Proposed Development – 2 to 6 Conway Avenue, 15 & 15A Fernleigh Avenue, & 38 to 40 Carlisle Street, Rose Bay

Preliminary Assessment of Potential Geotechnical Impacts on Neighbouring Properties

Our ref: JM/C17267_Rev1

Plate 4-2: Graphical Representation of the Depth of Expected Groundwater Drawdown at Distances Extending From the Excavation Boundary (not based on numerical modelling, as this has not been provided by the proponent)

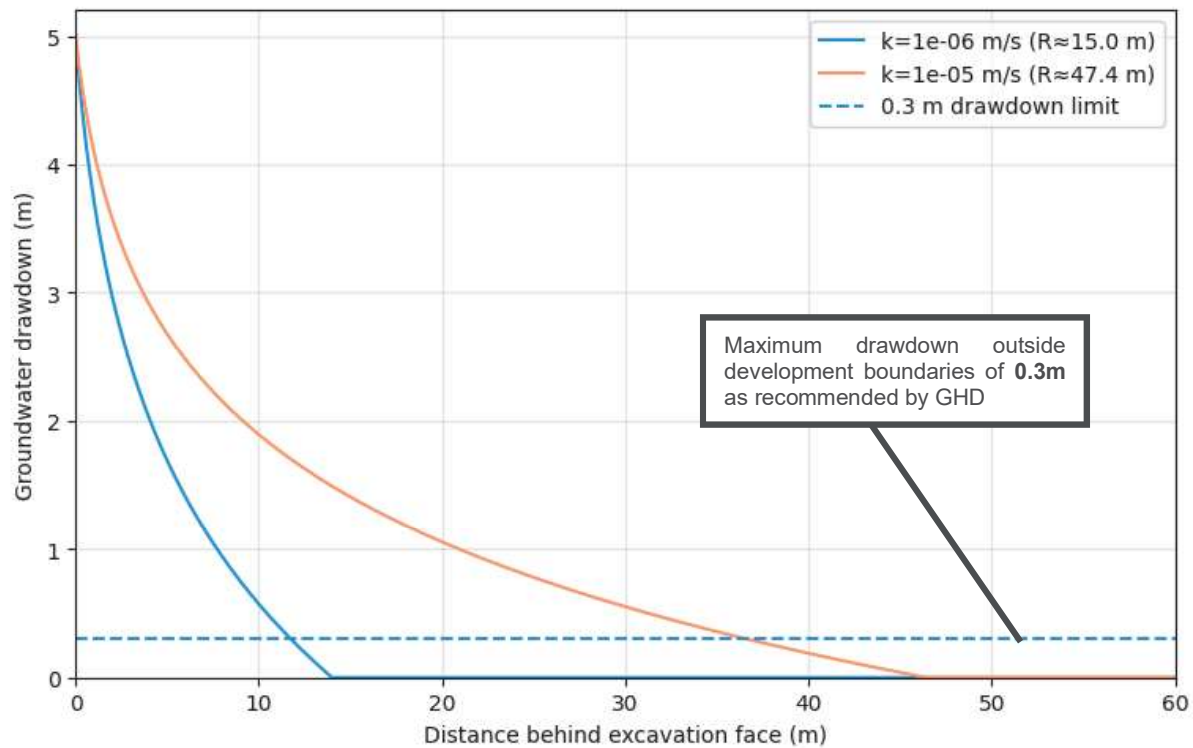
- Plate 4-2 below is a graph prepared by us based on our own assessment showing the potential groundwater drawdown at set-back distances behind the excavation shoring wall. It should be noted that this is our preliminary estimate, as no numerical modelling has been provided by the proponent.

- There are existing structures within 5m to 10m of the proposed excavation, and it is estimated that drawdown of the water table could be up to 2m depth at this set back distance. This could potentially result in ground settlement/subsidence up to 5mm/10mm (or more if the shoring deflects excessively), and expected damage to neighbouring properties includes internal cracking of plaster, external structural cracking of masonry, cracking of floor slabs and tiles, cracking of pools, etc.. We recommend that the development is redesigned so that groundwater drawdown on adjacent properties do not exceeds the 0.3m threshold recommended by the GHD report.

Plate 5-1 – Indicative markup provided by the client showing the development site (yellow), proposed LMR development sites (red), and known properties that have experience structural damage due to adjacent developments.

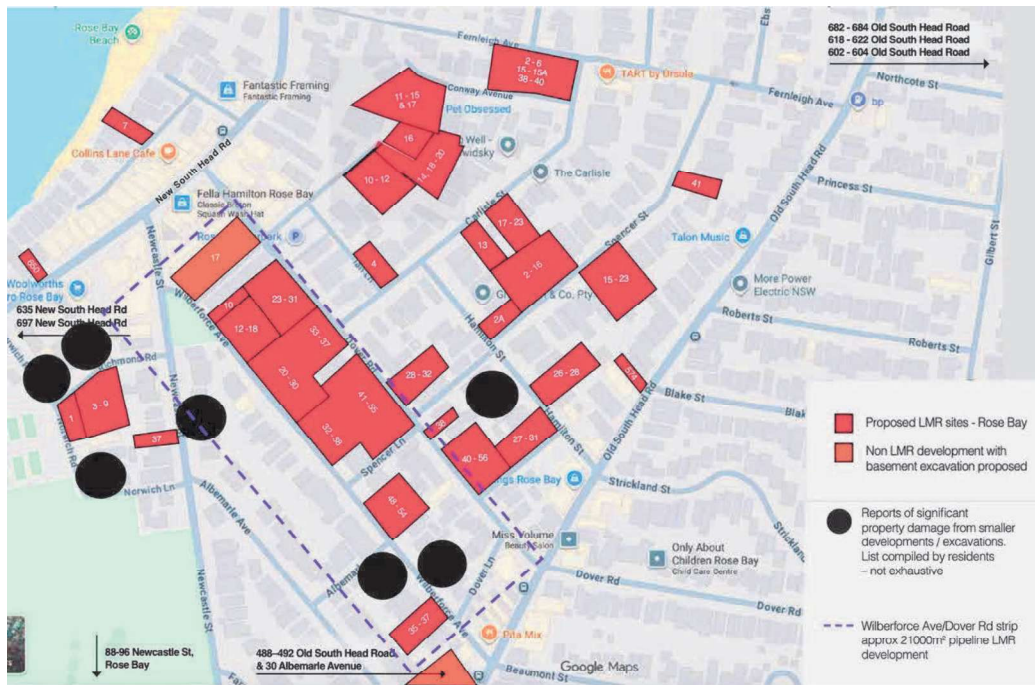
- Numerous instances in Double Bay and Rose Bay of structural cracking and damage to existing houses and apartments which are located near or adjacent to building sites where deep excavations with dewatering are being undertaken. Specific instances where structural damage to neighbouring properties that have been attributed to shoring installation (both from vibrations due to installation of sheet piling and over-flighting for bored piles), excavation and dewatering works in Rose Bay are shown in Plate 5-1 and include:

- o Norwich Lane – back wall came away from the neighbouring house
 - o Richmond Avenue – structural cracks appeared in block of neighbouring units (stop work issued).

- o Wilberforce Avenue – neighbouring house collapsed. The house was deemed unsafe for occupancy and it was subsequently sold and demolished.
 - o Wilberforce Avenue – the same above development caused flooding into the basement of a neighbouring house.

- o O'Sullivan Road – sink holes appeared in the road
